BOUNDARY SURVEY WITH CONCEPT PLAN FOR:  
**THE ESTATES AT WALDEN**  
 LAND LOT 610, 10th DISTRICT, 2nd SECTION  
 COBB COUNTY, GEORGIA

**PETITION NO:** Z-5

### **Z-5 BROOKS CHADWICK CAPITAL, LLC**

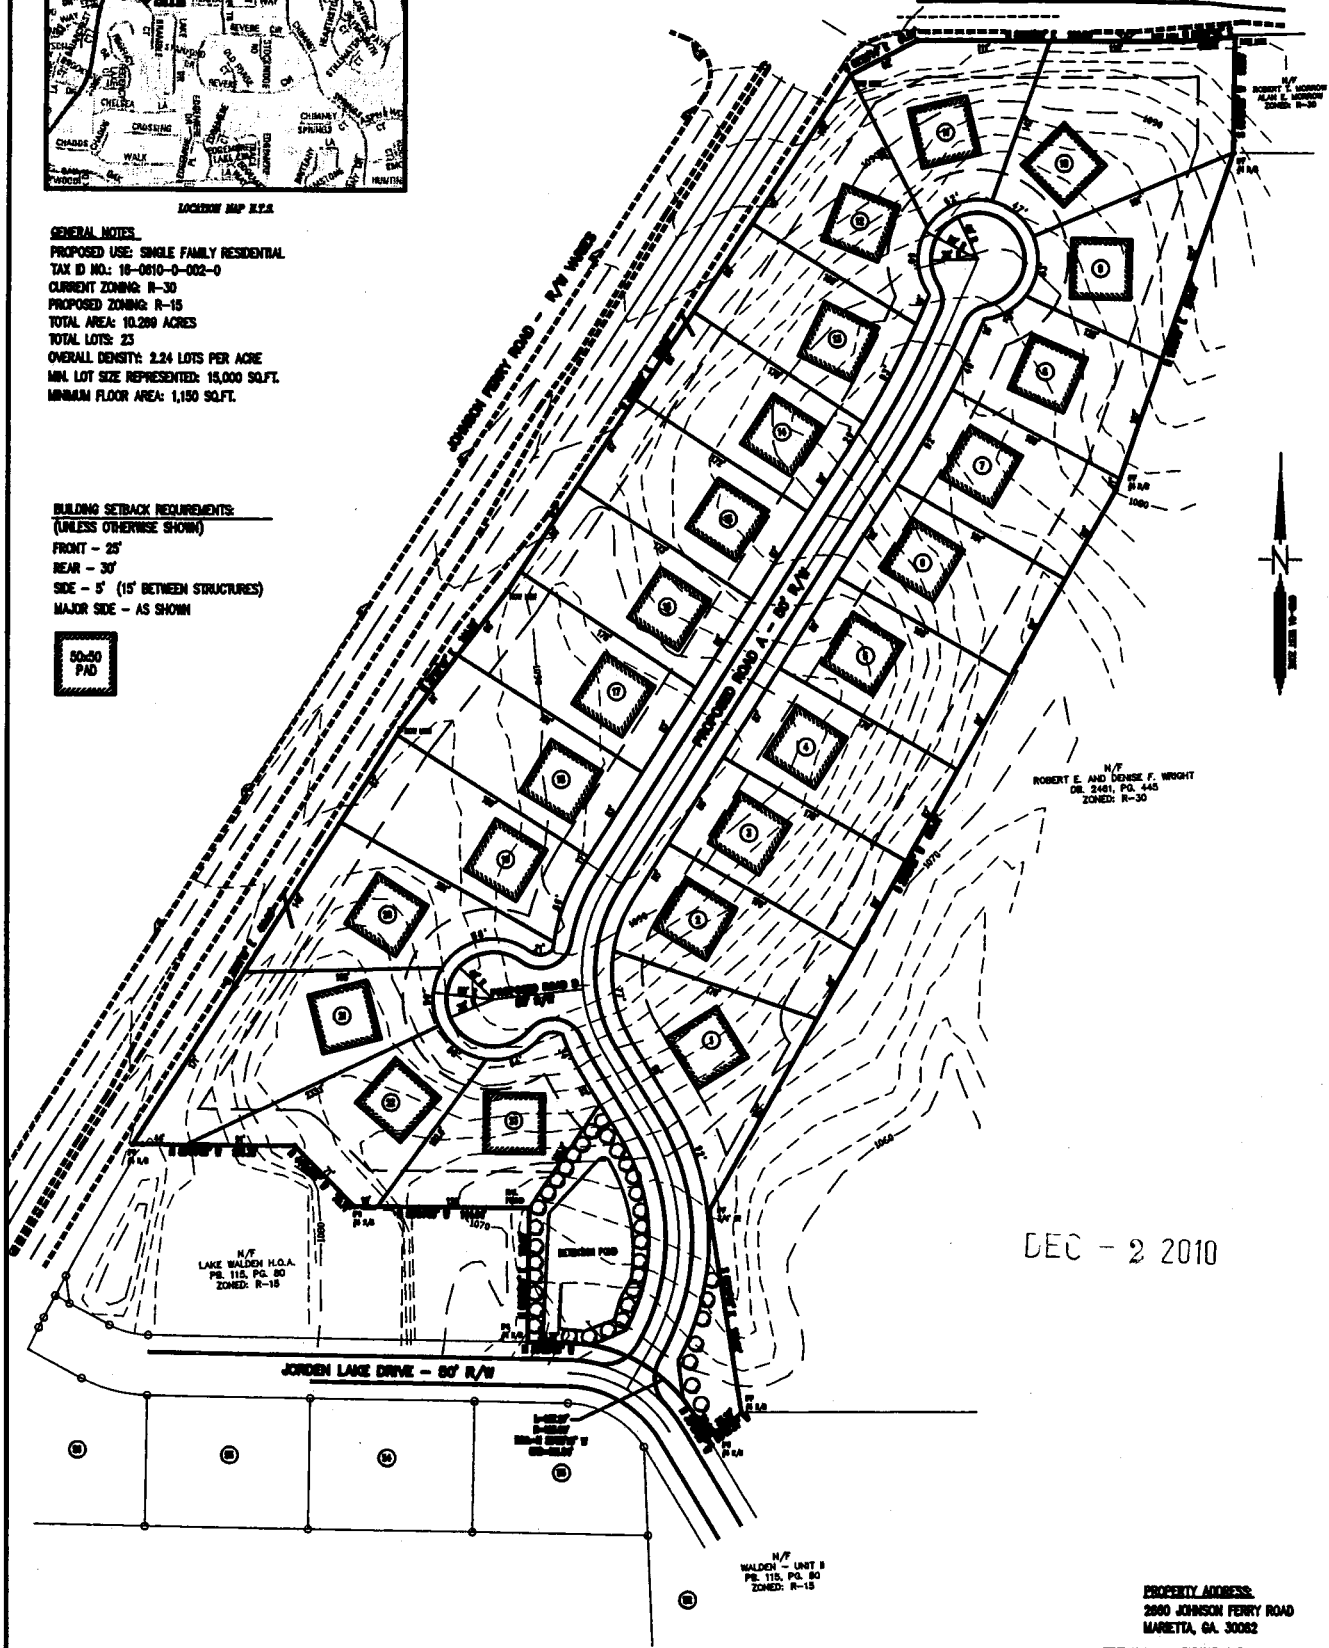
- No Stormwater controls shown \_\_\_\_\_
- Copy of survey is not current - Additional comments may be forthcoming when current site conditions are exposed.
- No site improvements showing on exhibit.

1. This site is divided into two separate basins. The northern two-thirds of the site drains to the east through the adjacent Wright parcel and private lake before flowing into the Walden Subdivision. The southern third of the site discharges directly into the Walden Subdivision through an existing pipe culvert located near the southeast corner the site. The allowable discharge for the proposed detention facility must be based on the existing basin area at this discharge point.

2. Due to existing drainage issues within the Walden Subdivision, uncontrolled bypass runoff must be limited. As a minimum, all front yards and front roof areas for lots 1-9 must be drained to the street or otherwise directed to the proposed detention pond.

3. If reinforced concrete walls are used for the detention pond, adequate landscape screening and/or decorative facing of the walls should be required.

4. As indicated in the downstream conditions comments, pre- and post-sediment surveys will be required for the two lakes located just downstream of this development – one located on the adjacent Wright property and Walden Lake within the Walden Subdivision. Downstream routings will also be required for both of these lakes as part of the downstream analysis to verify no adverse hydrologic impacts.

- Site plan received by the Zoning Division December 2, 2010, without any variances granted;
- District Commissioner approve the final site plan;
- Maximum impervious surface per lot not be exceeded, with site layout of every lot approved by Stormwater Management;
- District Commissioner approve house architecture;
- Fire Department comments;
- Water and Sewer comments;
- Stormwater Management comments;
- Cobb D.O.T. comments; and
- Owner/developer to enter into a Development Agreement pursuant to O.C.G.A. 36-71-13 for dedication of system improvements to mitigate traffic concerns.
